Well Name: PURE GOLD D FED	Well Location: T23S / R31E / SEC 28 / SWNW / 32.2772375 / -103.7901882	County or Parish/State: EDDY / NM
Well Number: 17	Type of Well: OIL WELL	Allottee or Tribe Name:
Lease Number: NMNM40659	Unit or CA Name:	Unit or CA Number:
US Well Number: 3001527112	Operator: OXY USA INCORPORATED

Type of Submission: Notice of Intent	Type of Action: Plug and Abandonment
Date Sundry Submitted: 05/28/2025	Time Sundry Submitted: 01:22
Date proposed operation will begin: 06/28/2025

NOI TO PERMANENTLY ABANDON THIS WELL VIA CEMENT PLUGGING.

REVISED

Proposed Wellbore
PURE GOLD D FEDERAL 017

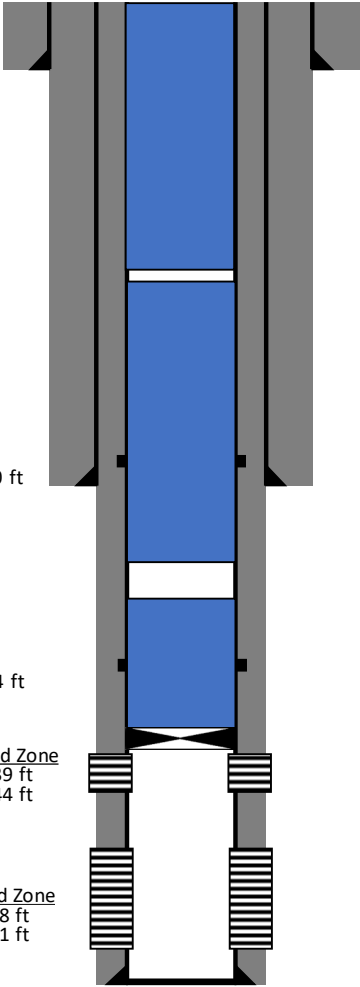
SPOT 267 SX CMT FROM 2200' TO
SURFACE. VERIFY CMT TO SURFACE.

SPOT 271 SX CMT FROM 4232' TO 2000'
WOC AND TAG

SET CIBP @ 6589'. LEAK TEST 500 PSI 30 MIN
SPOT 190 SX CMT FROM 6589' TO 4983'
WOC AND TAG

Proposed Wellbore

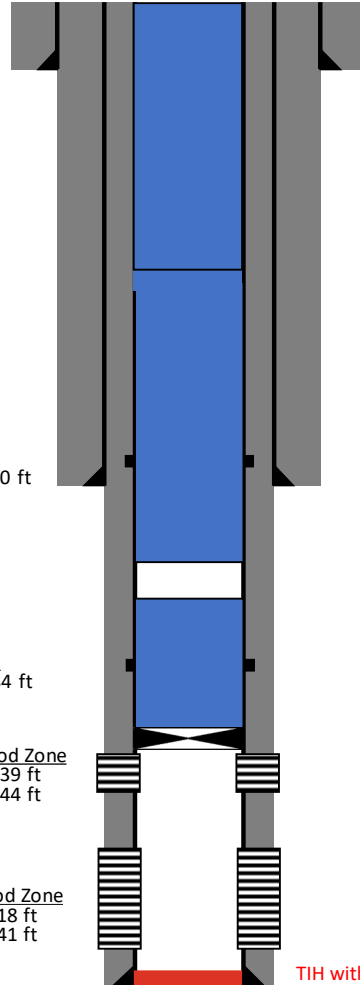
*Run CBL from CIBP to surface.

Submit results to BLM.

TIH with Gauge ring and tag
PBSD. Spot 25 sxs o top.
Class H. WOC and Tag.**REVISED**

1. POOH WITH EXISTING 2-7/8" TBG AND BHA
2. **TIH with gauge ring and tag PBTD. Spot 25 sxs on top. WOC and Tag.**
3. SET CIBP AT 6589' VIA WORKSTRING. LEAK TEST TO 500 PSI FOR 30 MINUTES
4. **Run CBL from CIBP to surface.**
5. SPOT 190 SX CL C CMT FROM 6589' TO 4983'. WOC AND TAG
6. SPOT 271 SX CL C CMT FROM 4232' TO 2000'. WOC AND TAG
7. SPOT 267 SX CL C CMT FROM **2000'** TO SURFACE.
8. VERIFY CMT TO SURFACE

SPOT 267 SX CMT FROM 2000' TO
SURFACE. VERIFY CMT TO SURFACE.SPOT 271 SX CMT FROM 4232' TO 2000'
WOC AND TAGSET CIBP @ 6589'. LEAK TEST 500 PSI 30 MIN
SPOT 190 SX CMT FROM 6589' TO 4983'
WOC AND TAG
